Alert Service Bulletin

TB No. AA-13062 **No Revision** December 17, 2013

SUBJECT:	HYDRAULIC TEST SWITCH	
PARTS AFFECTED:	VIA-350-24-001 & VIA-350-24-002 Console Upgrade Kits per STC SR00825NY-D	
HELICOPTERS AFFECTED:	EUROCOPTER AS-350 series aircraft with Aeronautical Accessories' Console Upgrade Kit installed.	
COMPLIANCE:	This bulletin shall be complied no later than June 30, 2014.	
DESCRIPTION:	The purpose of this bulletin is to provide instructions for the replacement of toggle switch P/N MS24523-23 with a lever-lock toggle switch P/N MS24658-23F to prevent madvertent activation of the HYD TEST switch.	
FAA/ODA APPROVAL:	The engineering aspects of this Alert Service Bulletin are FAA/ODA approved.	
MANPOWER:	Approximately 1.0 man-hours. (Manhours are based on hands-on time and may vary with personnel or facilities available).

Figure 1

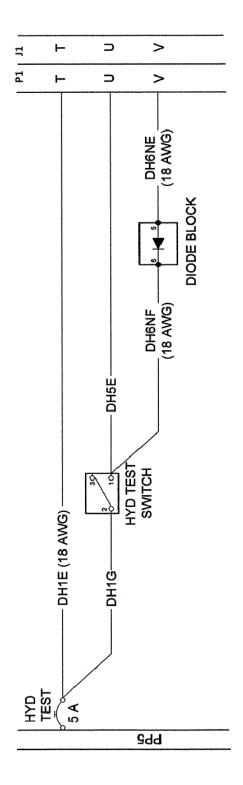
- **5.8** Install new MS24658-23F switch in HYD TEST switch location with new hardware provided with switch
- **5.9** Reinstall ring terminals onto new HYD TEST switch with new screws provided with switch. Reference Fig 1 for correct wiring installation
